**RECREATIONAL VEHICLE CUSTOMER SATISFACTION**

Customer Satisfaction Campaign: 22-425

**CUSTOMER SATISFACTION CAMPAIGN**

Keystone is conducting a Customer Satisfaction Campaign for certain 2021 - 2022 Cougar Travel Trailers and Fifth Wheels. With some models and features, the Display Commander (LCD screen) for the In-Command system, may exhibit erratic readings on HVAC and/or lose communication with components. This is caused because Keystone may not have installed an End of Line (EOL) Resistor in the "Gateway" located in the Roof A/C. This resistor is installed in the last component in the line of components that communicate with the In-Command system.

Fig. 1

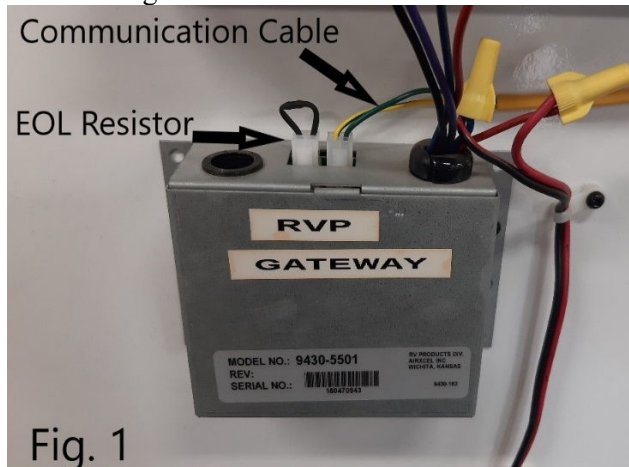
Figure 1-Shows a Gateway, the communication cable from In-Command system and the EOL resistor as it should be for proper operation.

4. Note: When a 2<sup>nd</sup> A/C is installed later, unplug the EOL resistor from the 1<sup>st</sup> Roof A/C Gateway, reinstall the 2<sup>nd</sup> A/C communication cable. Install the Pre-wired Communication cable and the EOL resistor into the 2<sup>nd</sup> A/C Gateway as seen in Figure 1.

Fig. 2

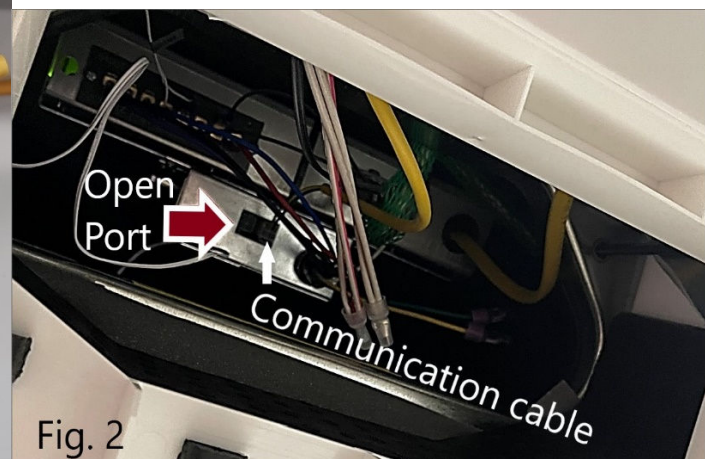
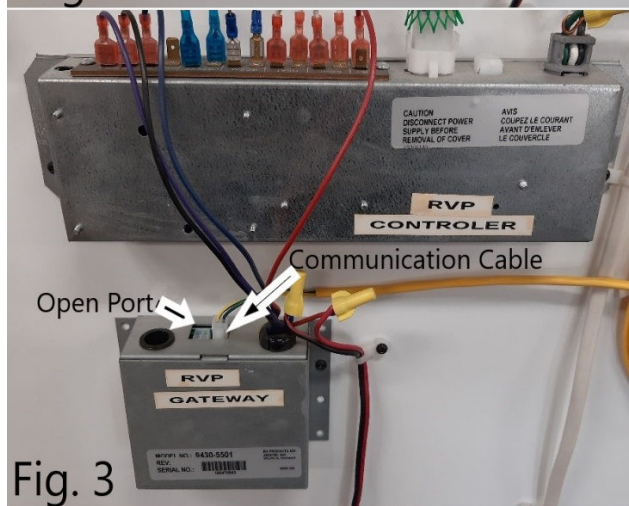
1. System with one Roof A/C. Turn off the A/C, remove the return air grill, and locate the Gateway (See Figure 2). If there is an open port as seen in Figure 2 & 3, corrective action is needed. Upon completion, the wiring should be as seen in Figure 1.

Fig. 4

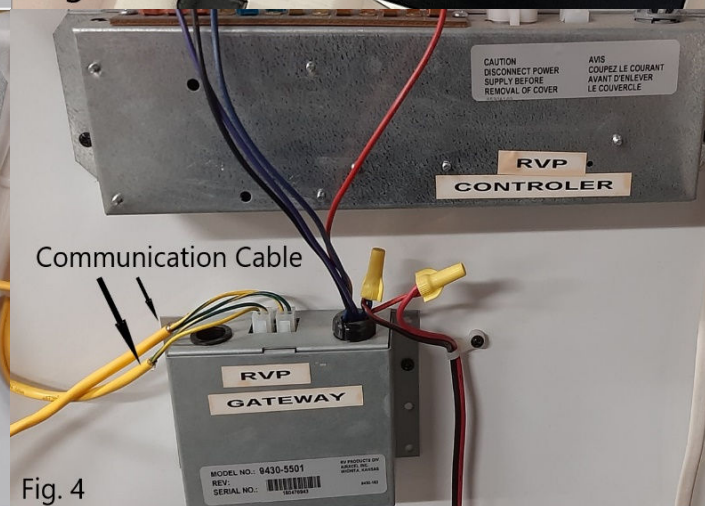
2. System with two Roof A/C's. Turn off the A/C's, remove the return air grill, and locate the Gateway's. The EOL will need to be installed on the 2<sup>nd</sup> A/C's Gateway. The first A/C Gateway (typically the middle of the unit) will have two communication cables plugged in (See Figure 4). One cable from In-Command to the 1<sup>st</sup> A/C, one cable from the 1<sup>st</sup> A/C to the 2<sup>nd</sup> A/C. The second A/C Gateway should look like Figure 1, if not, take corrective action.

3. System with one Roof A/C and Pre-Wired for 2<sup>nd</sup> A/C. If Pre-Wired for 2<sup>nd</sup> A/C, the 1<sup>st</sup> A/C Gateway may have two communication cables plugged in, See figure 4. One cable from In-Command to the 1<sup>st</sup> A/C, one cable from the 1<sup>st</sup> A/C to the 2<sup>nd</sup> A/C. The 2<sup>nd</sup> A/C communication cable will need to be unplugged and the EOL Resistor will need to be plugged in to that port. See Figure 1. The 2<sup>nd</sup> communication cable can be left protected and unplugged. To determine which communication cable is "live" unplug one cable at a time and operate the A/C functions at the In-Command panel.
